OCEANO COMMUNITY SERVICES DISTRICT ADDENDUM NO. 1 TO OCEANO DRAINAGE UTILITY RELOCATION PROJECT OCEANO, CA CONTRACT NO. 2019-02

Certain revisions are hereby incorporated into the Contract Documents for the subject project. These revisions are as follows:

- **5.** Replace project plans (Sheets 1-4) with the new sheets 1-4 attached to this addendum. Revisions include, but are not limited to the following:

DRAWN BY	DATE	CA JOB NO.
_	KM	01/19/2018	170828
	CHECKED BY	SCALE	SHEET
		AS SHOWN	3 OF 4

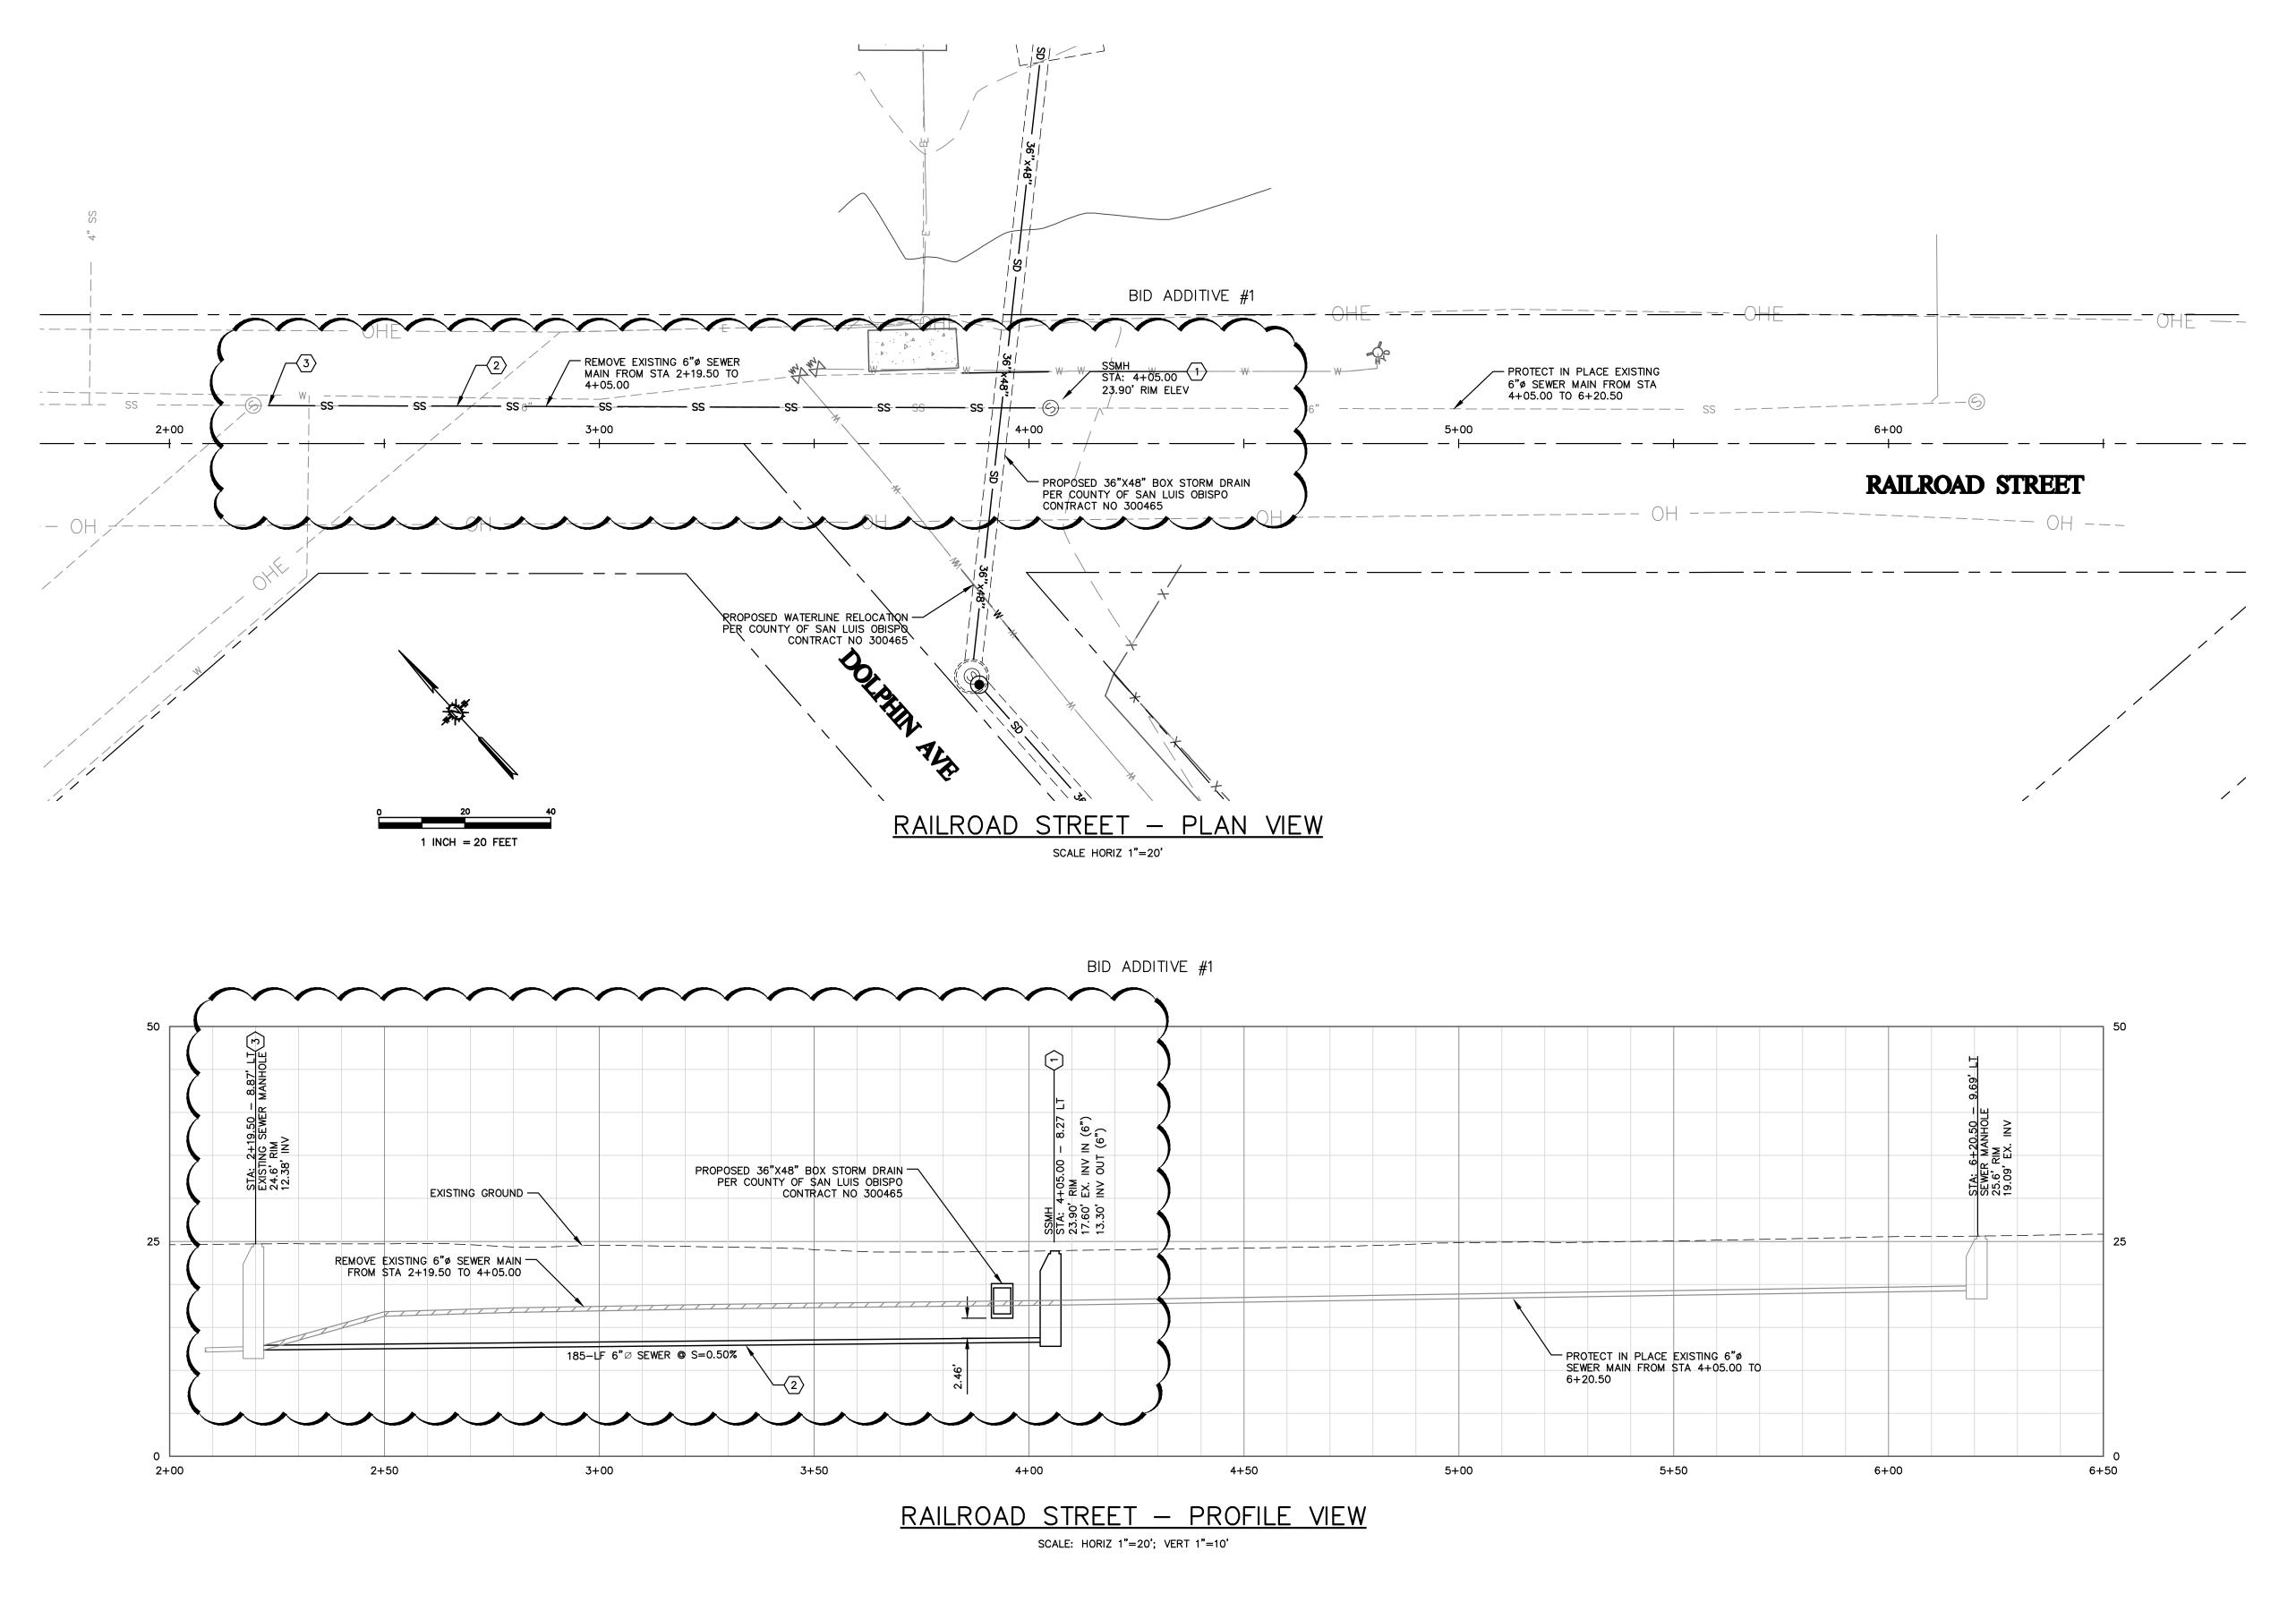
- c. Sheet 3 of 4: The installation of a new sewer manhole and the lowering of the portion of line between the new manhole and the existing downstream manhole has been removed from the base bid of this project. This work (shown in a revision cloud in both the plan and profile views) shall be included in the project bid schedule as "Bid Additive #1".

DRAWN BY	DATE	CA JOB NO.
KM	01/19/2018	170828
CHECKED BY	SCALE	SHEET
	AS SHOWN	4 OF 4

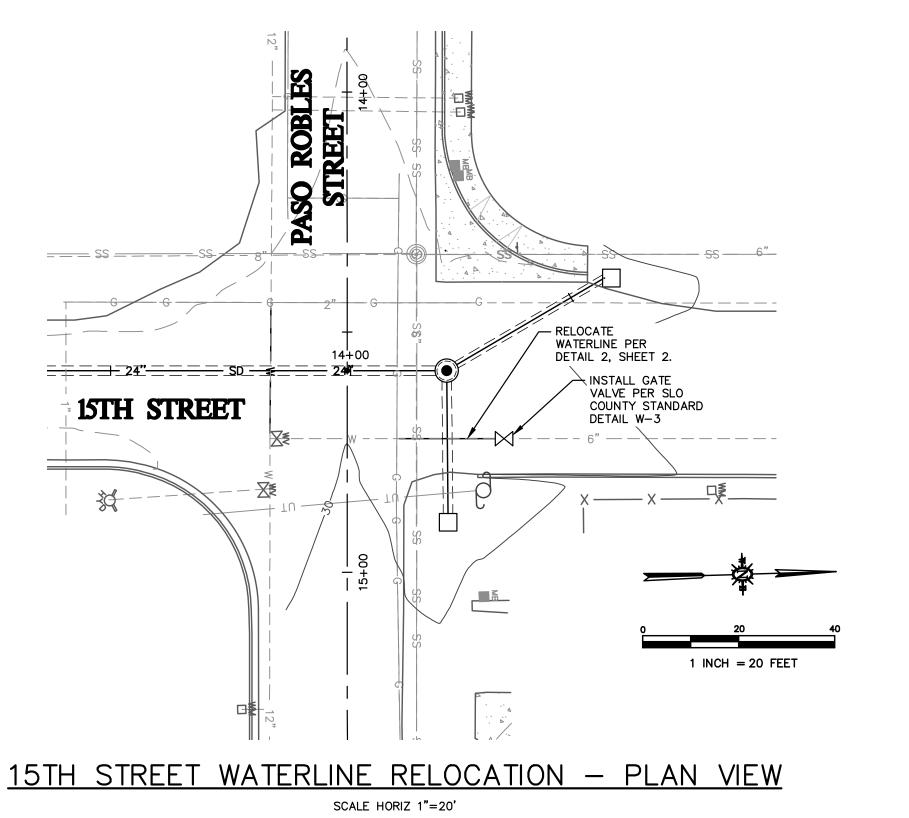
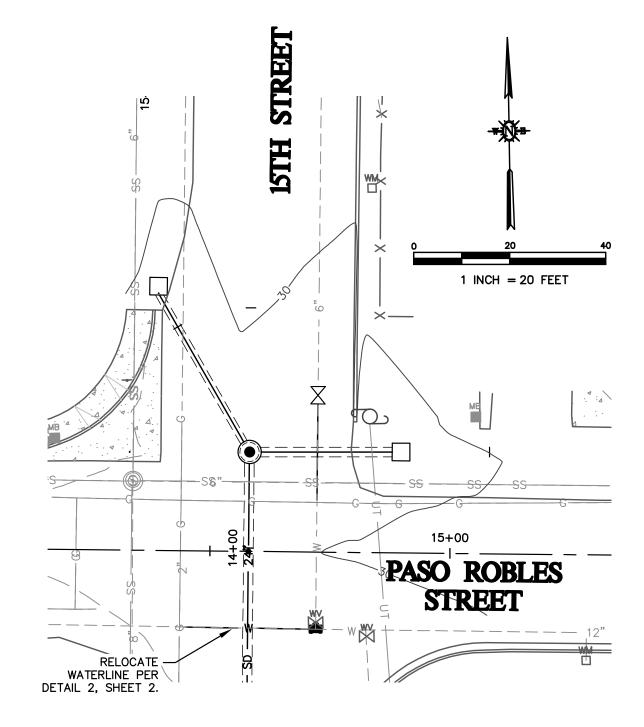
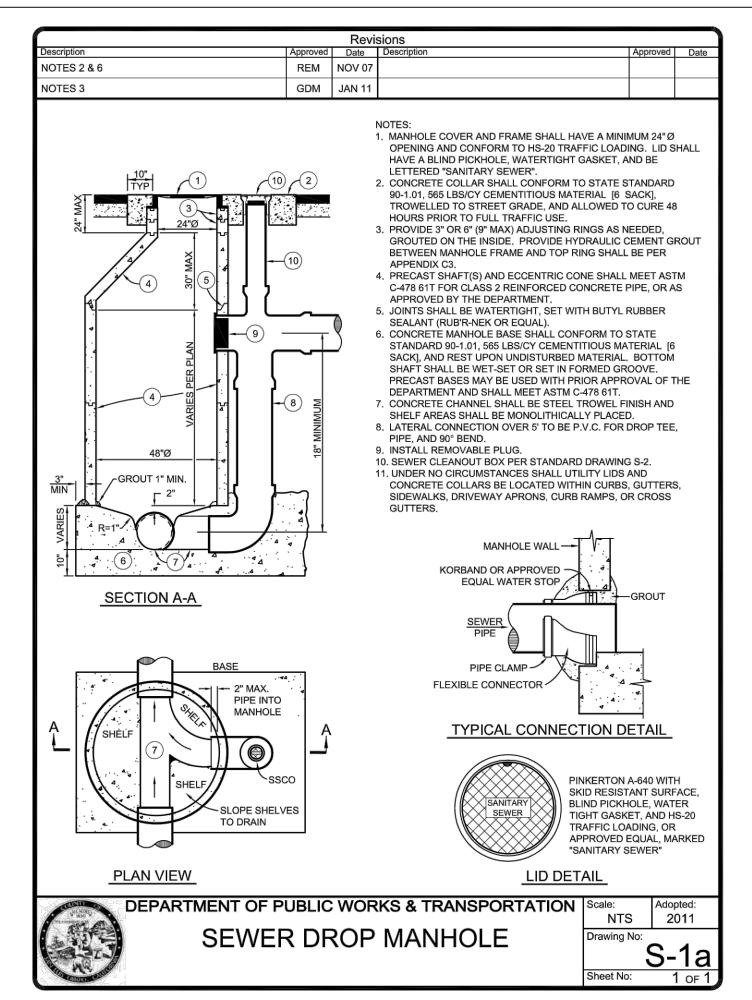
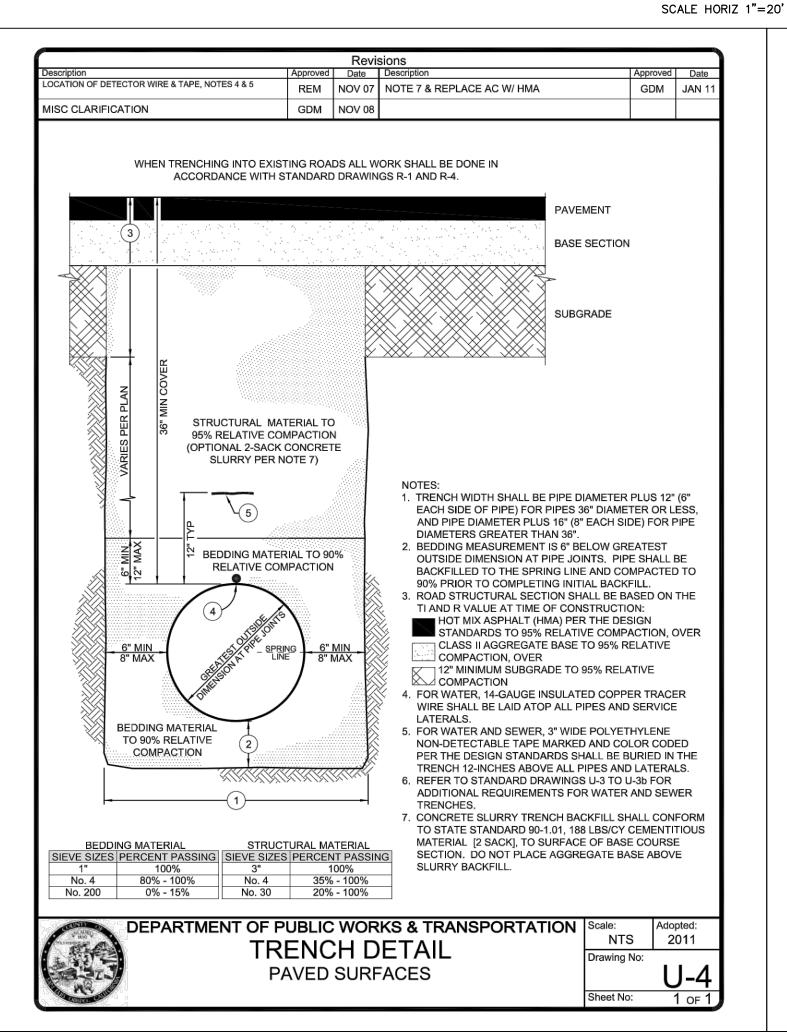
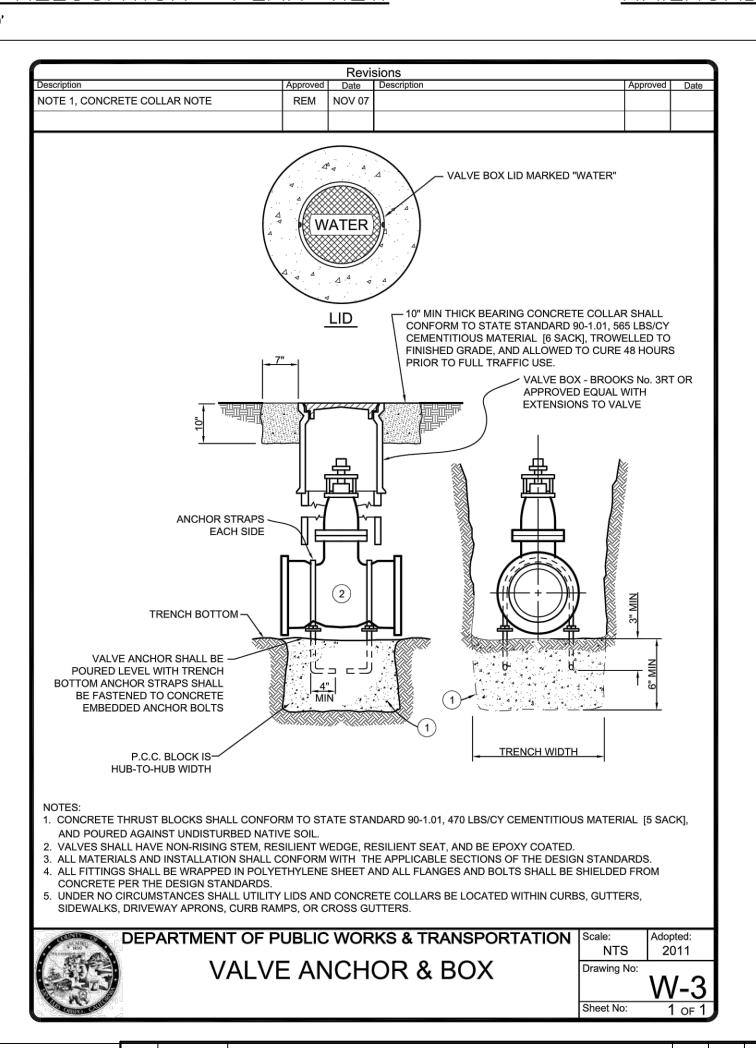
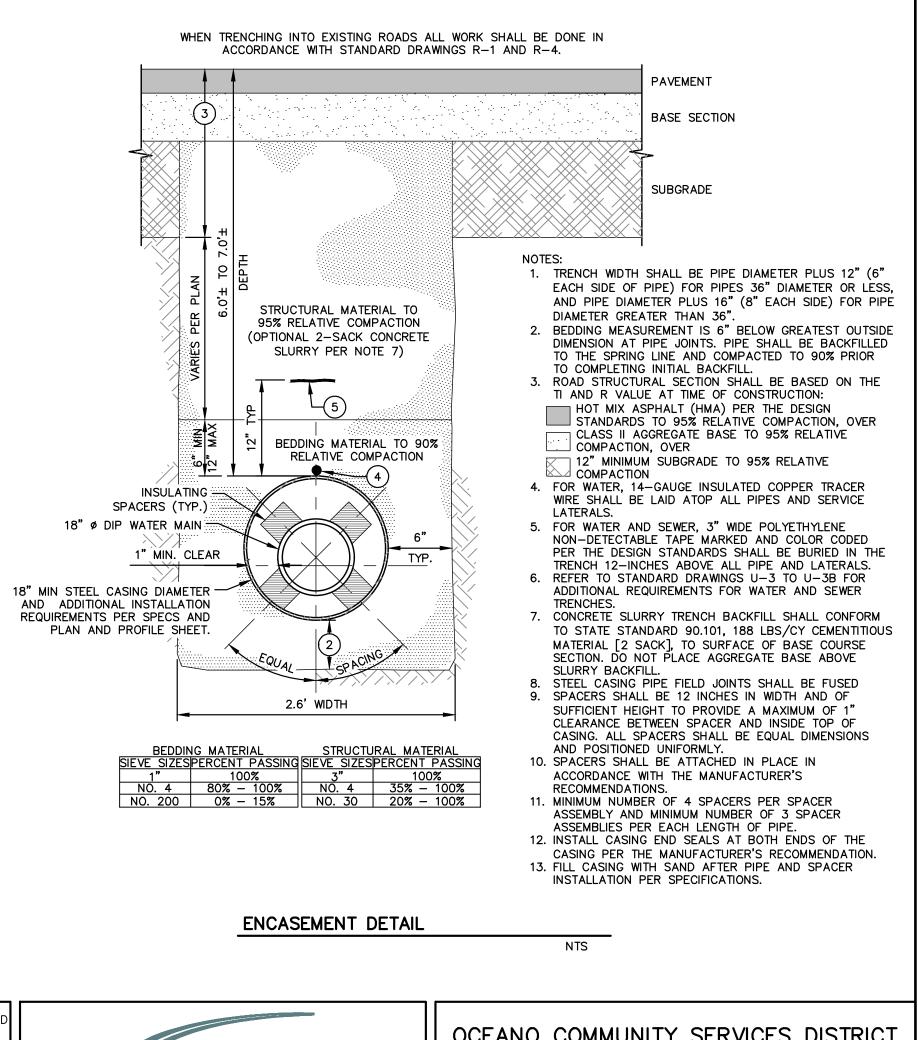
- d. Sheet 4 of 4:
 - i. "15th Street Waterline Relocation Plan View" has been modified to include a new gate valve.
 - ii. "Paso Robles Street Waterline Relocation Plan View" has been modified:

- 1. The note stating "RELOCATE WATERLINE PER DETAIL 3, SHEET 2." has been removed.
 - 2. A new note stating "RELOCATE WATERLINE PER DETAIL 2, SHEET 2." has been added.

- 3. "VALVE ANCHOR & BOX" (Drawing No. W-3 of SLO County Department of Public Works & Transportation) has been added.
 - 4. "ENCASEMENT DETAIL" has been added.
